**TOWN OF WELLINGTON
PLANNING COMMISSION
November 7, 2022
6:30 PM**

Date: November 7, 2022
Submitted By: Paul Whalen, Planner III
Subject: Site Plan Review – Lots 1 & 2, Block 2, Bonfire Subdivision 2nd Filing

Site Plan Review – Lots 1 & 2, Block 2, Bonfire Subdivision 2nd Filing

PROJ. NO.:
DATE: 09.08.22
SCALE: See Sheet
DRAWN: JRO
CHKD BY: NAM
SHEET
L10

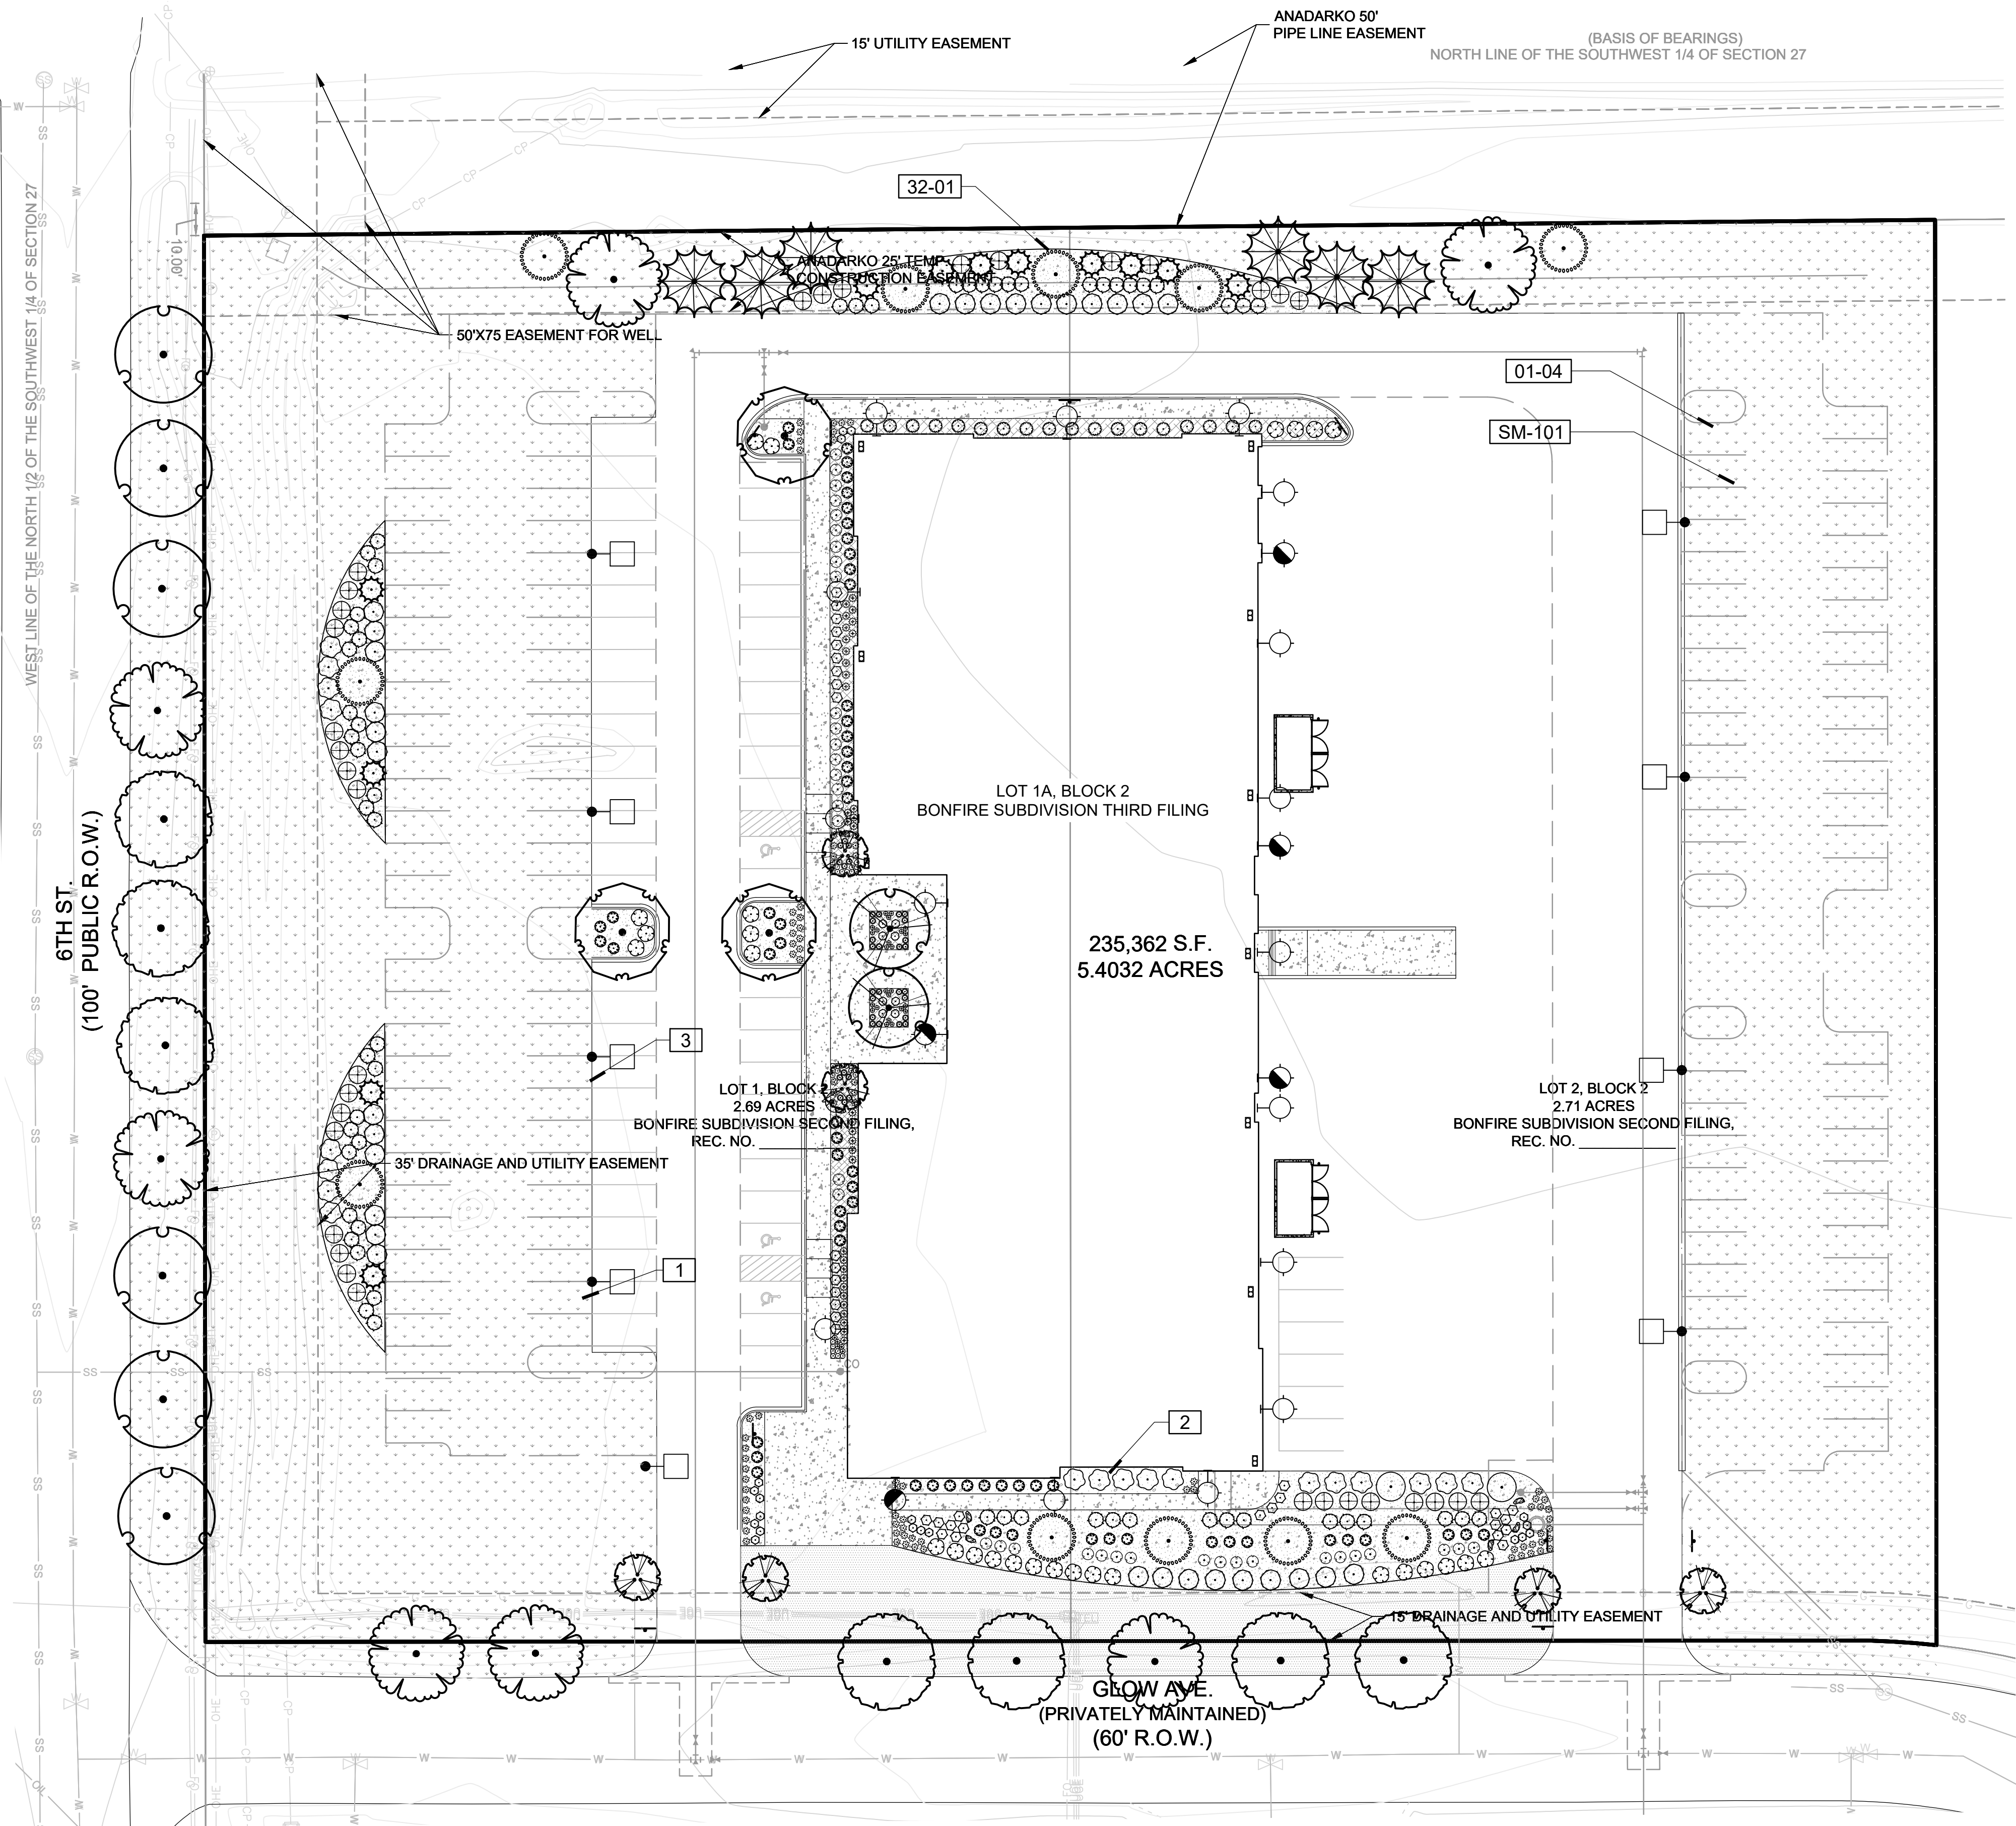
2. The proposed street and site tree locations and species will define the property perimeter, accentuate the architecture, and screen the parking lot. The tree planting rhythm adds character to the 6th Street and Glow Avenue ROW, creates a sense of arrival to visitors, and provides privacy to the building occupants.

- **Parking Lot Trees/Shrubs/Screening:** Parking lots are required to provide trees in islands and shrubs for screening and buffering. A sufficient number and species of trees and shrubs are proposed to meet the parking lot island requirements and to screen the parking lots from 6th Street and Glow Avenue. Parking lot screening needs some additional changes or adjustments to ensure effective

PROJ. NO.:
DATE: 09.08.22
SCALE: See Sheet
DRAWN: JRO
CHKD BY: NAM
SHEET
L2.0

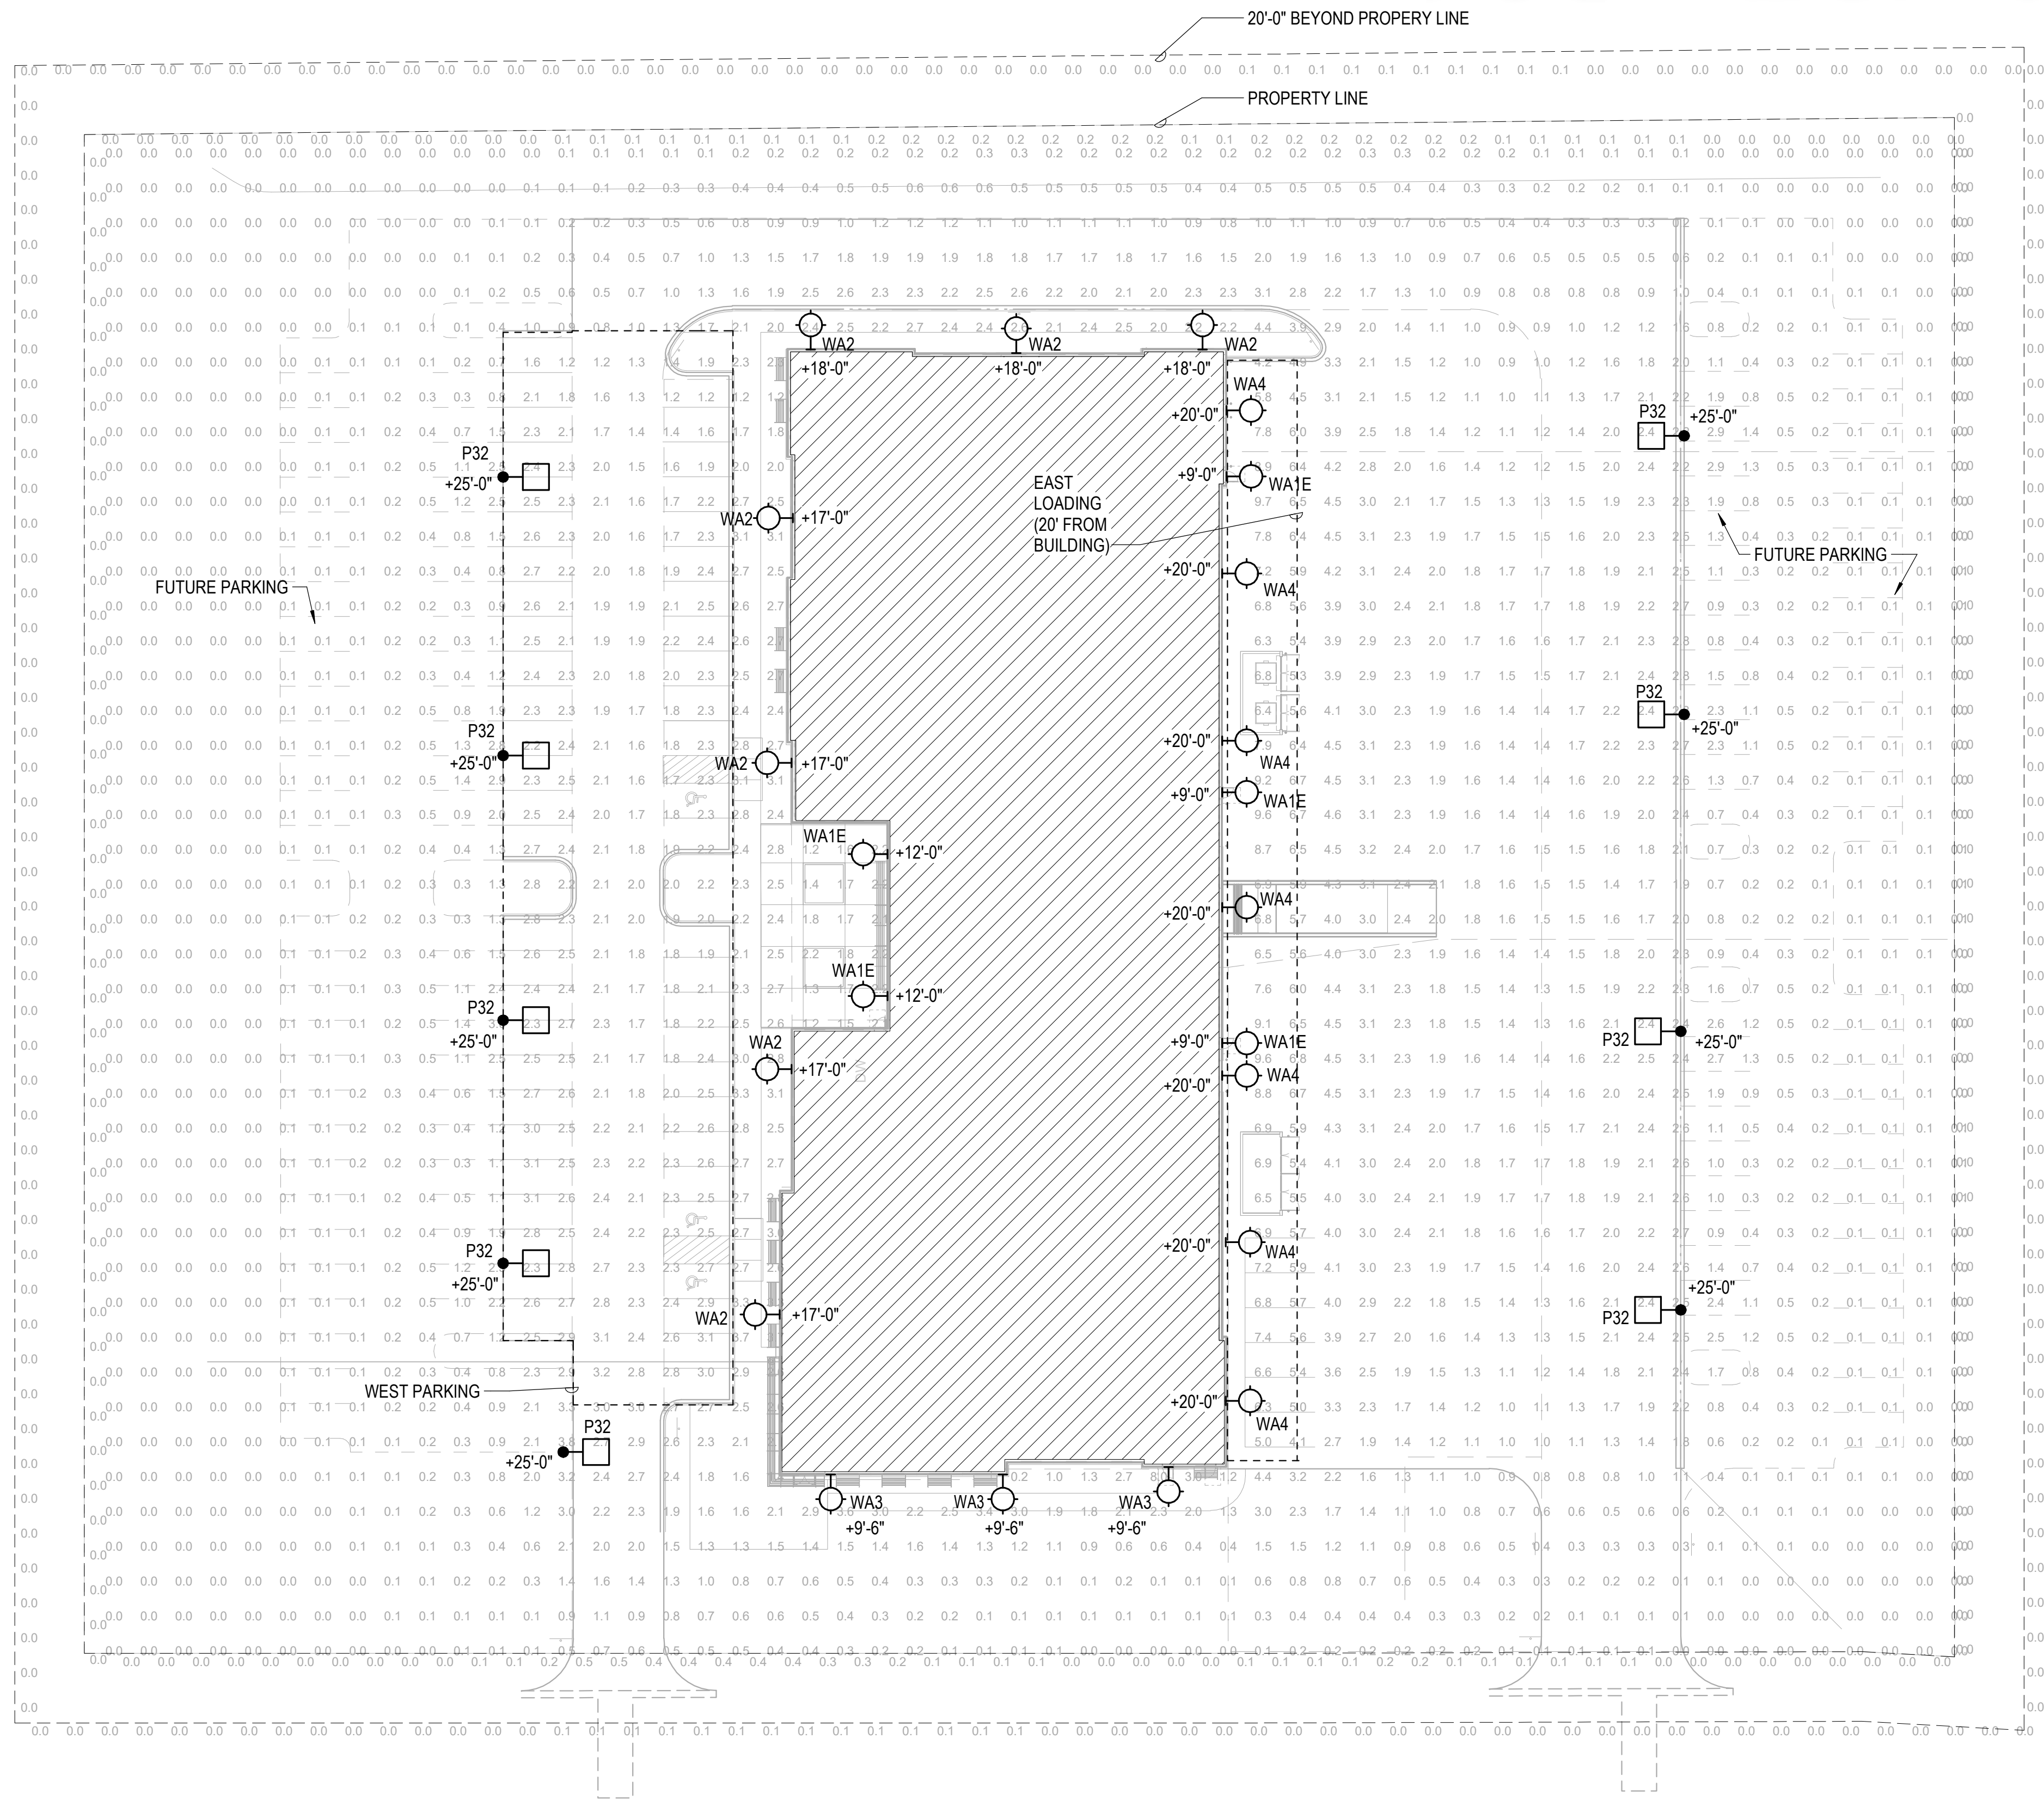
2. The shrubs counts are consistent with the required quantity and the (314) is reflected in the Landscape Requirement Chart on Sheet L2.0. The final landscape plan shall represent accurate numbers and statements in accordance with the Landscape Requirement Chart.
